Product hierarchy no. *				Part no.	SBU	Type / Description	Customer part no.
SBU	PG	PUG	Type				
90	004	004	0000001008		Voltage Selector	SWM1 (Frontpl)

Product Change Notification					SWM nut change second step		
owner	creation date	release date	released by	change order no	rev	page	D10-056-473
zeierjo	08.04.2021	21.09.2021	haeckima	2021508	A	1 of 2

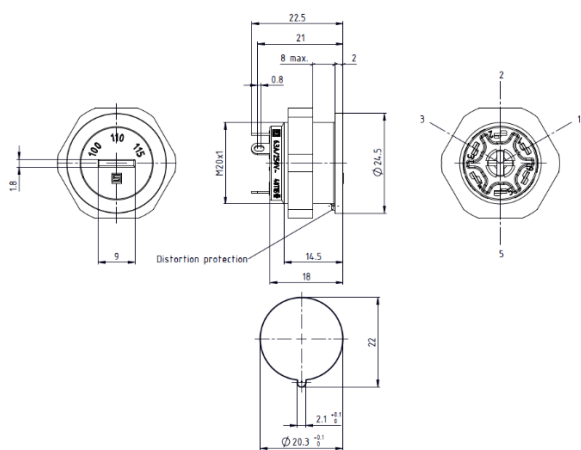
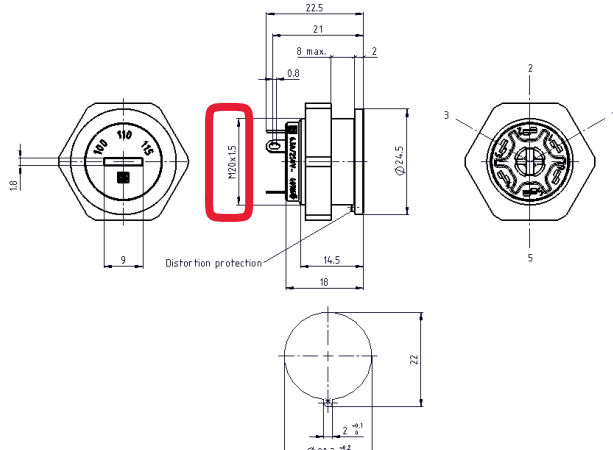
The locknut and the socket of the SWM voltage sector changes to a M20x1.5 thread (previous M20x1).

Old product dimensions	New product dimensions
 <p>Hexagonal locknut M20x1, socket M20x1</p>	 <p>Hexagonal locknut M20x1.5, socket M20x1.5</p>
Old packaging	New packaging
 <p>Cardboard box 178x91x71, quantity 50 pcs</p>	 <p>Cardboard box 200x170x85, quantity 100 pcs</p>

Form	Yes	No action needed as the new locknut is shipped together with the new socked.
Fit	No	
Function	No	
Manufacturing	No	
Label	No	
Packaging	Yes	The size of the cardboard box has changed. Consider your logistic implication.
